Eraring Power Station Justification for Urban Classification

Date:	25 February 2022	Jacobs Group (Australia) Pty Limited
Project name:	Eraring Battery Energy Storage System	Level 4, 12 Stewart Avenue
Project no:	IS365800	Newcastle West, NSW 2302
Attention:	Tariful Islam	PO Box 2147
Company:	NSW EPA:	Dangar, NSW 2309
Prepared by:	Sean Brennan & Dave Davis	Australia
		T +61 2 4979 2600
		F +61 2 4979 2666
Copies to:	Quentin Large, Marianne Gibbons	www.jacobs.com

Figure 4-1 Examples of the time periods during which industrial noise was clearly dominant, and isolated from the overall background noise levels for further analysis

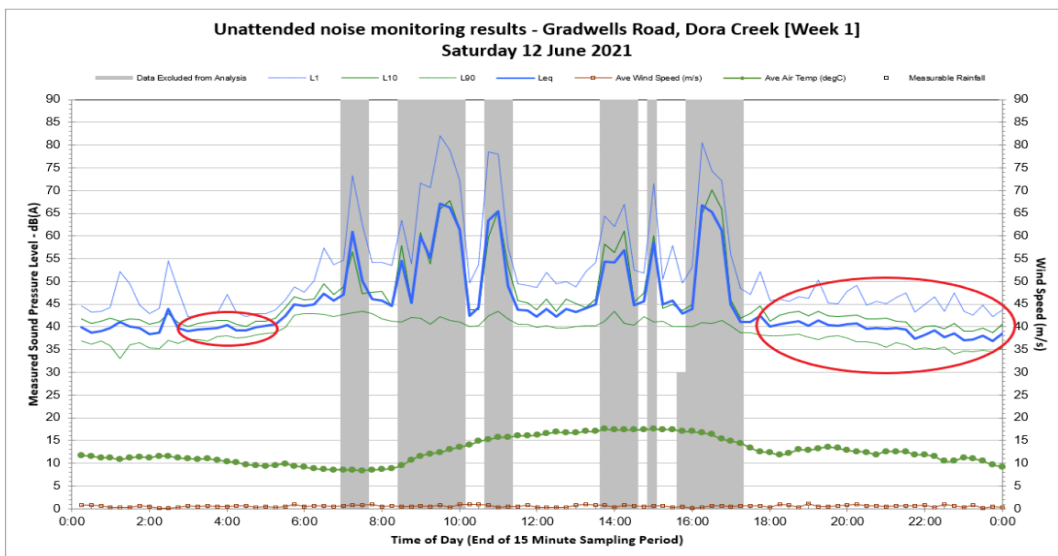
"Table 4.7 presents the project amenity noise levels (PANL). TANU notes that the noise amenity area derived from zoning considerations only been adjusted based on the background noise monitoring results. As alluded to above, there appears to be some confusion about the background noise monitoring results that needs to be resolved in the first instance before further consideration can be given to the adjusted noise amenity area. However, as an initial observation, the daytime and evening background noise levels as a group do not support allocation of the urban noise amenity area to NCAs 1, 3 and 4. EPAs initial position is that a suburban category would apply unless further justification can be supplied."

The adoption of an urban amenity area classification for NCA 1 and NCA 3 is further demonstrated by the detailed data analysis described above. The measured noise data and the audio sound recordings were reviewed to identify time periods when industrial noise was clearly audible and was obviously the dominant source of noise in the environment at the time. These data samples were then used to identify and isolate additional time periods throughout the monitoring period during which the power station and/or the nearby coal mine were the most audible noise sources. It was clear from inspection of the monitoring data that regardless of the variation of noise from other environmental noise sources at any time during the day, evening or night, the noise levels at NCA 1 and NCA 3 never dropped below the baseline level of industrial noise, which remained relatively constant. It was found that the industrial noise created a 'floor' for background noise, which held the prevailing background noise of the area to between 35 and 40 dB(A). This is displayed in the red circled areas in Figure 4-1 below.

After identification of the time periods when industrial noise was dominant, the isolated sections of the audio recordings were passed through a digital signal filter to eliminate frequencies greater than 800Hz (since based on Jacobs' experience, frequencies less than 800Hz are typical of industrial noise).
